21 Pitt Street,
PO Box 6345, Auckland,
1141, New Zealand
T: +64 9 300 9000 // F: +64 9 300 9300
E: info@beca.com // www.beca.com

SH16 Brigham Creek to Kumeū Stage 2 - Notice of Requirement Further Section 92 Responses

Figure 1: Location of Tree Group 108 within existing Waka Kotahi Designation 6768

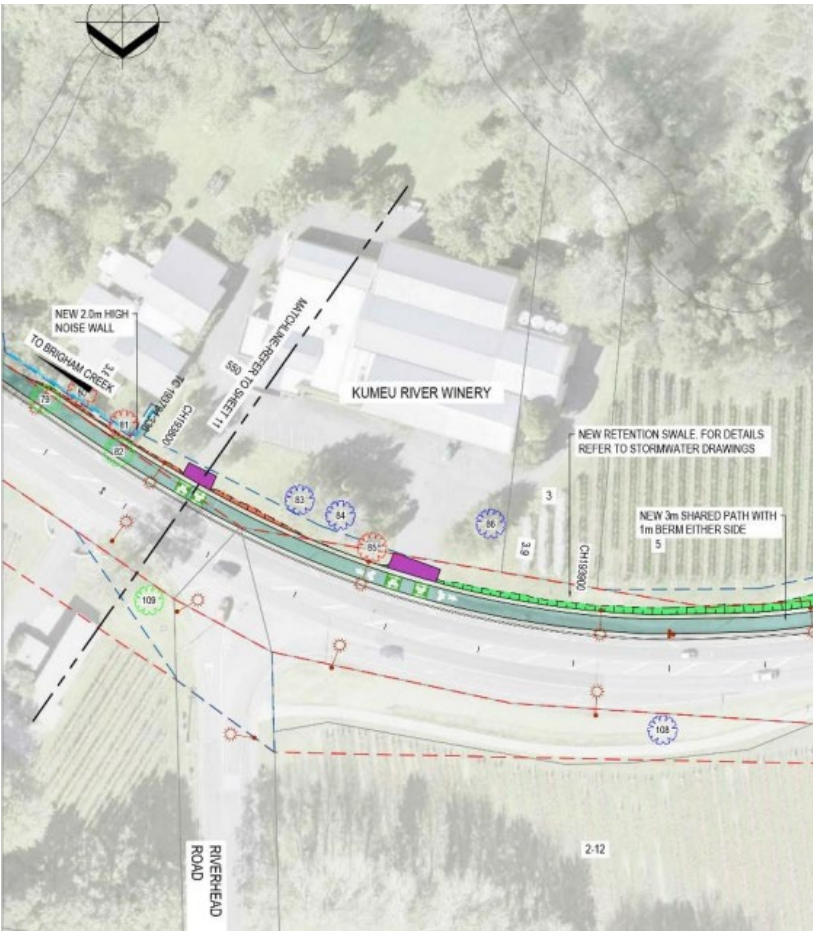
- 1. My query was about why some existing street trees worthy of protection (also identified in the arb report) and which will be within the works footprint (new street landscaping) are not shown on the plans. The plans contain a key item for this purpose and multiple instances where non-notable trees are shown on the plans and noted to be protected and retained if possible.**

Macrocarpa, Poplar, Totara, Oak, Radermachera, Puriri, Magnolia, Kauri, Liquidamber, Ash and other unidentified trees (not notable) are labelled on the landscape plans for retention if possible, however, the street trees I have highlighted are not. This is inconsistent and implies that trees not noted on the drawings are not recorded and noted in the existing environment and worthy of protection if possible.

Updated drawings have not been provided to give effect to the comment. It is unclear why a note to protect most trees is provided on the drawings and others are not. This implies that only the identified trees are intended to be retained if possible, or simply reflects an inconsistent approach.

Therefore, in my opinion, the drawings warrant being updated to also note the trees in group 108. This would make the drawings consistent with the written s92 explanation.

In summary, it is acknowledged that tree group 108 is not specifically recorded on the Landscape and Ecological Planting Plans as being protected/retained. However it is confirmed that tree group 108 will be protected and retained, as clearly evidenced within both the tree survey / plans within the Arboricultural Report and on the Site Clearance Plans. As a result, it is considered unnecessary to make any updates to the Landscape and Ecological Planting Plan. The purpose and content of the various Project plan sets included within the lodgement documentation is set out below.

Tree Group 108 is within the existing Waka Kotahi designation 6768 for road widening purposes and could be removed by Waka Kotahi as the Requiring Authority for that designation (so long as Waka Kotahi also has ownership of the land). However it is confirmed (as shown on Site Clearance Plan – Sheet 12) that these trees are outside of the proposed physical works area and are to be protected and retained.

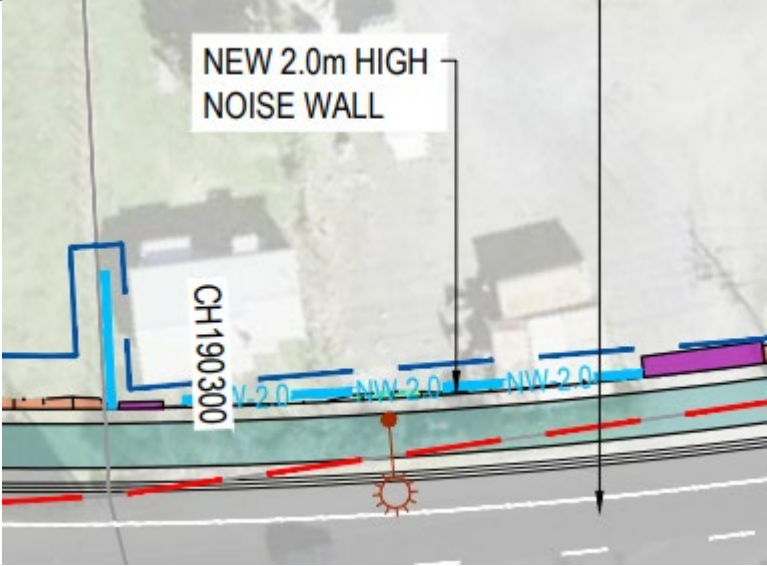
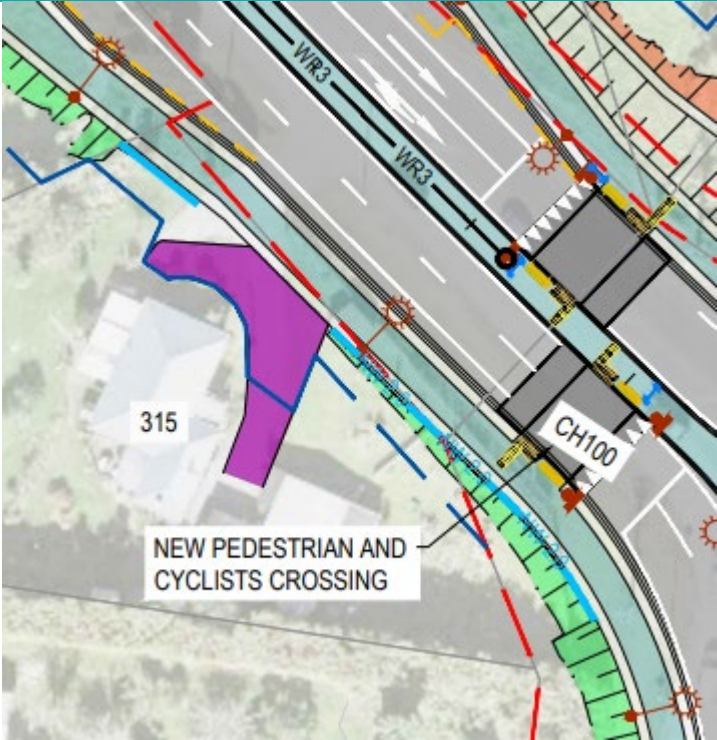
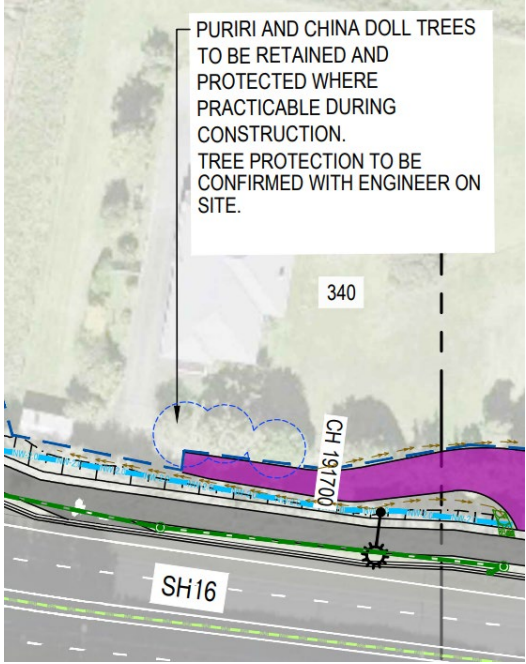
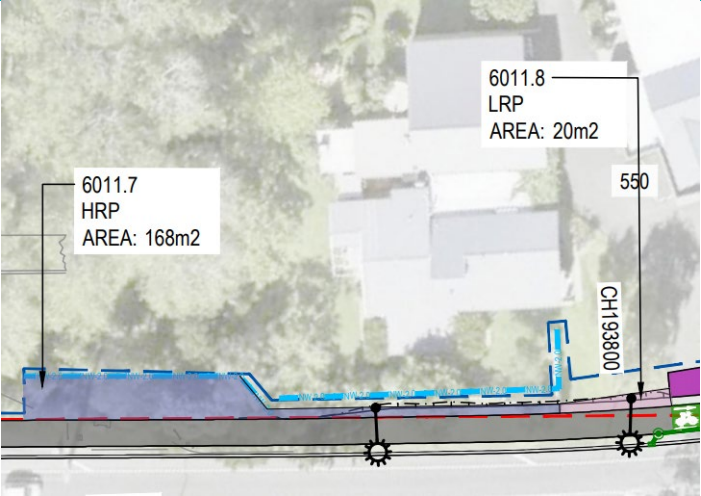
9. While the majority of noise walls are suitably screened, the following are not and consideration should be given to mitigating effects: 218 SH16, 315 SH16, 340 SH16, and 550 Sh16 (low amenity planting only).

Please provide justification for why these areas are not screened?

Space constraints along the corridor have limited the opportunities to provide larger screen planting in these areas. Decisions to omit larger specimen plants or planting altogether in some places was balanced against onsite constraints that would result in other adverse effects if mitigation planting was prioritised. A site-specific analysis is provided in the following Table:

Property	Justification
218 SH16	 Figure 9: Snip of 218 SH16 taken from the General Arrangement Plans There is a small strip of land available between the proposed SUP and the proposed noise wall. However, the strip is only 1.6m wide. Due to the minimum 700mm offset requirement of planting from the edge of the pathway for safety reasons, practically there may only be space to provide low level amenity planting adjacent to the noise wall. Requiring land to accommodate screening planting would result in the need to shift or remove the existing dwelling which is considered unreasonable. The accessory buildings immediately west of the existing dwelling shown on the aerial are no longer located there.
315 SH16	 Figure 10: Snip of 315 SH16 taken from the General Arrangement Plans

Property	Justification
	There is insufficient land area available between the proposed SUP and the proposed noise wall to accommodate larger amenity planting or between the existing driveway/dwelling and the proposed noise wall within the site. Requiring land to accommodate planting would result in the loss of onsite vehicle manoeuvring area that is required to ensure vehicles can exit the site facing forward to achieve safe egress. A loss of sufficient vehicle manoeuvring area would result in vehicles reversing out of the driveway straight onto the state highway which is unsafe at this location.
340 SH16	 PURIRI AND CHINA DOLL TREES TO BE RETAINED AND PROTECTED WHERE PRACTICABLE DURING CONSTRUCTION. TREE PROTECTION TO BE CONFIRMED WITH ENGINEER ON SITE. 340 CH 191700 SH16 Figure 11: Snip of 340 SH16 taken from the Landscape and Ecological Planting Plan The narrow corridor width reduces opportunities for larger amenity planting without requiring additional land to accommodate this. A greater land requirement will result in impacts on established trees within the site that are intended to be retained and further reduction of onsite driveway width. The retention of these trees will maintain some screening of the proposed wall for the occupants of the dwelling.

Property	Justification
550 SH16	 Figure 12: Snip of 550 SH16 taken from the Landscape and Ecological Planting Plan The noise mitigation design here will be integrated with the existing yellow concrete block wall which is being retained at the request of the landowners (see Figure 13). Therefore insufficient land area is available in front of the wall to provide for larger plants between the SUP and the wall at this location without requiring the removal of the existing wall.  Figure 13: Streetview of the existing concrete block wall at 550 SH16
